POSTAL EMPLOYEES SUBDIVISION

APPLICATION NUMBER 6 DATE July 17, 2014

REQUEST Subdivision

DETAIL SITE PLAN

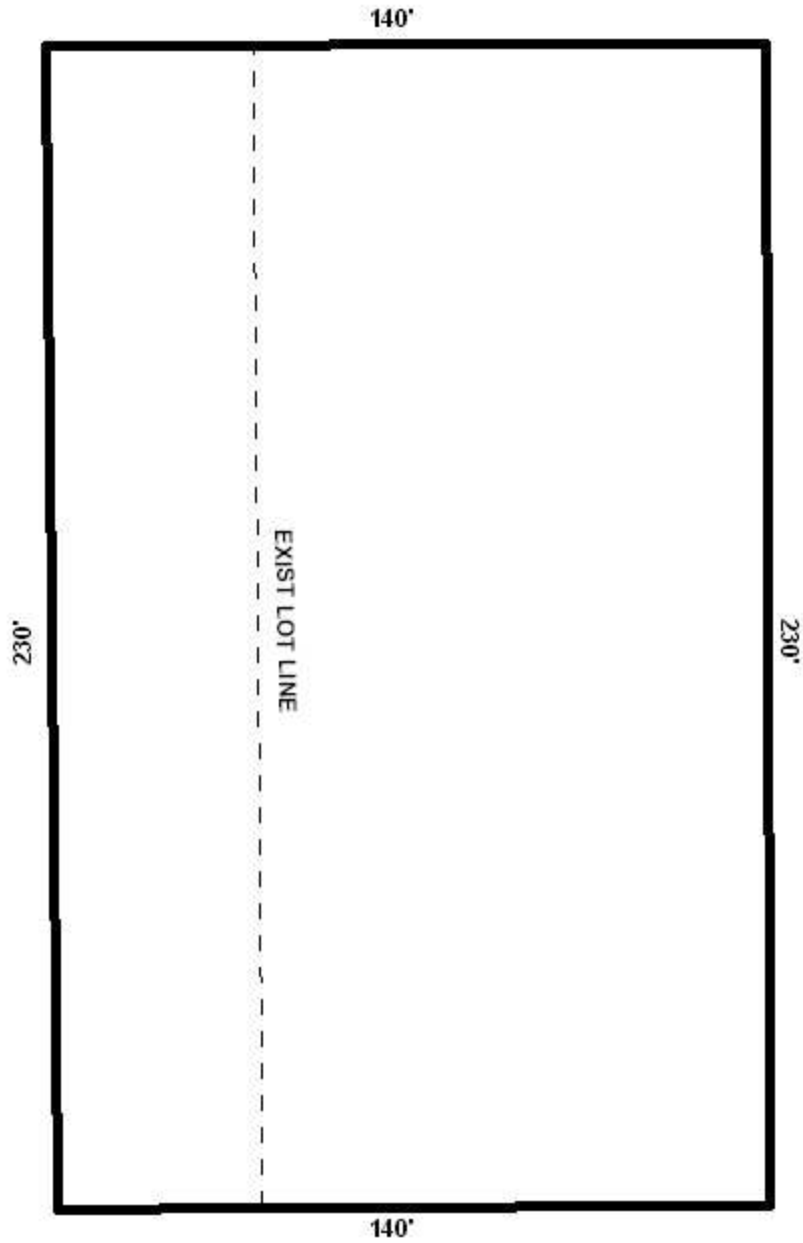
The lot size is not labeled in square feet or acres, but appears to meet the minimum size requirements of Section V.D.2. of the Subdivision Regulations. The lot size should be placed in square feet and acres on the Final Plat, if approved.

The site fronts onto Midmost Drive, a minor street with curb and gutter, and is illustrated as having a compliant right-of-way of 60-feet; therefore no dedication should be required. If approved, a note should be placed on the Final Plat limiting the lot to one curb cut, with the size, design, and location of the curb cut to be approved by Traffic Engineering and conform to AASHTO standards.

The preliminary plat does not illustrate the 25' minimum building setback line, as required in Section V.D.9. If approved, the minimum building setback line should be illustrated on the Final Plat.

- 1) illustration and labeling of the 25' minimum building setback line;
- 2) placement of a note stating the lot size in square feet and acres on the plat;
- 3) placement of a note stating the development is limited to one curb cut with the size, location and design of all curb cuts to be approved by Traffic Engineering and conform to AASHTO standards;
